Attachment 3

Responses to DEQ Comments and Corresponding Additional Information

Attachment 3 - Buck – Site Specific NCDEQ comments and Responses

SURROUNDING PROPERTY OWNERS
DUKE ENERGY CAROLINAS, LLC
BUCK STEAM STATION ASH BASIN
ROWAN COUNTY, NORTH CAROLINA

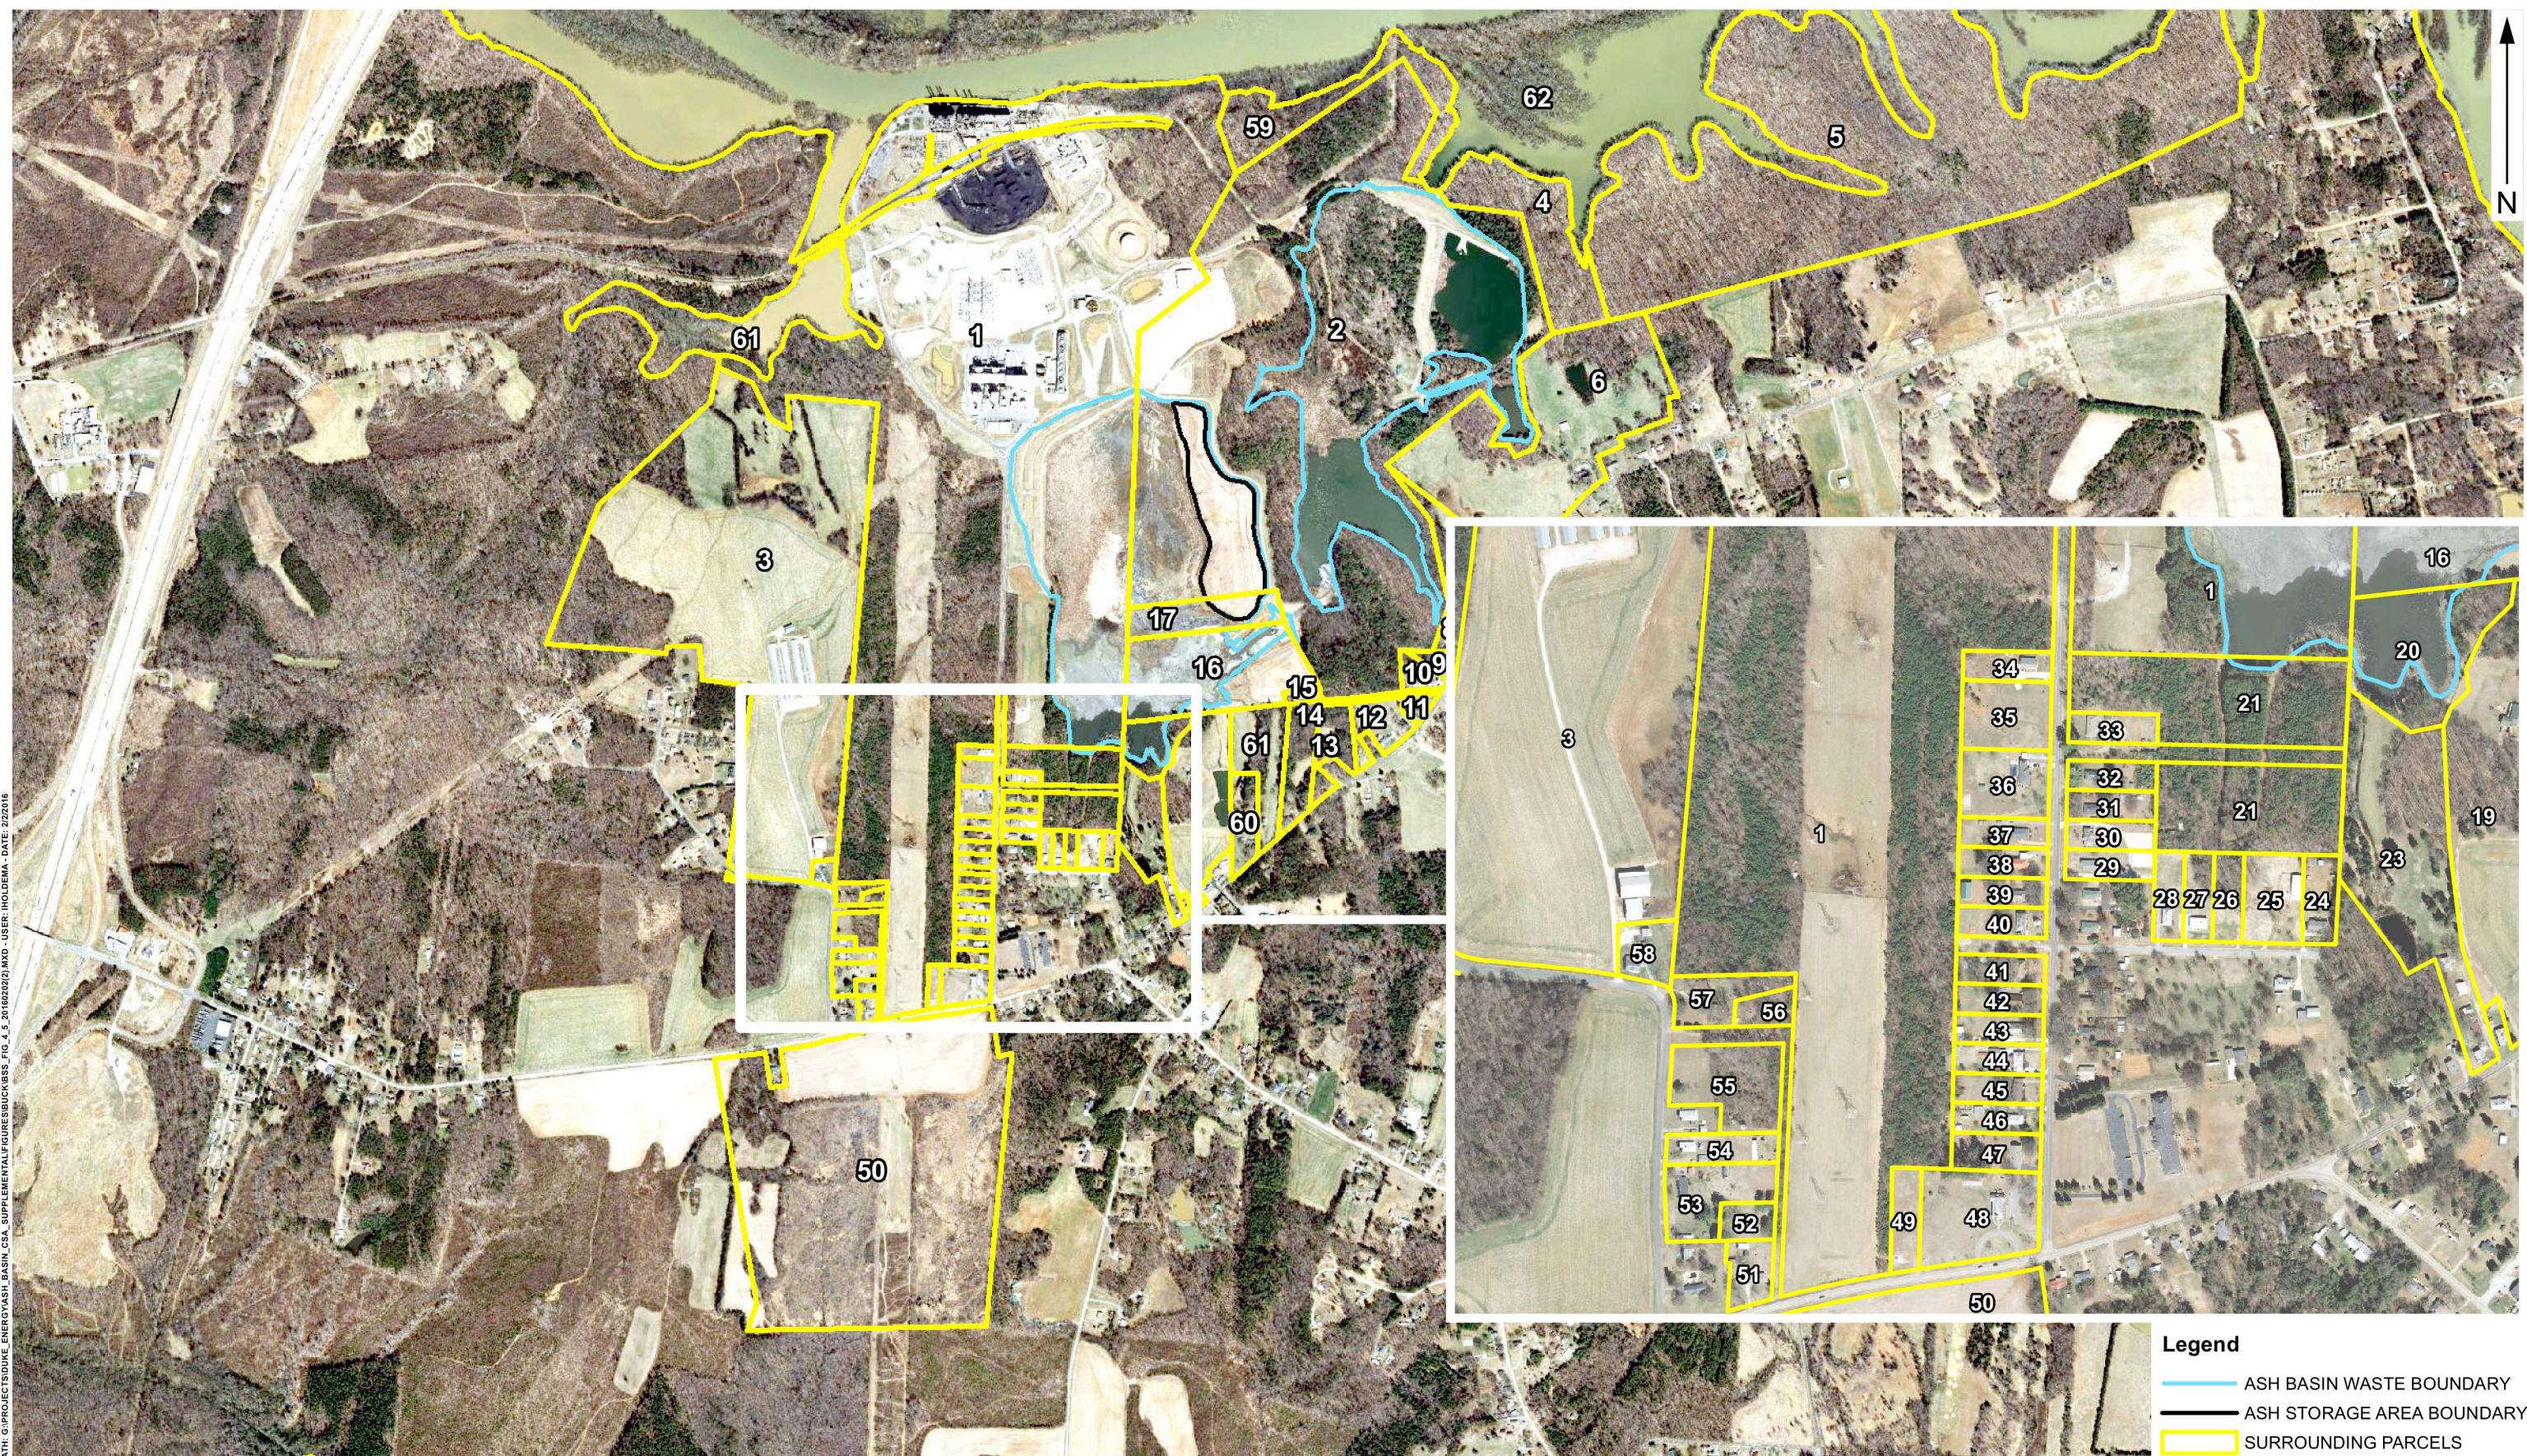
19	There is an Alcoa property boundary at the Yadkin River, how does this effect CAP? Note this on applicable figures.	A revised CSA Figure 4-5 and Table 4-2 with the Alcoa property boundary displayed has been included in this Attachment 3. The Alcoa property is addressed with the groundwater to surface water modeling in the CAP reports.
20	Section 10.1, Inconsistency of relevance to standard, ensure constituents are discussed if they are mentioned in reference.	Groundwater constituents of concern are compared to NCDEQ 2L standards.
21	X-sections, make sure "East-West" is correct	The East/West labels on the CSA Figures 8.2 through 8.4 and 10.52 through 10.55 (cross-sections) are correct.
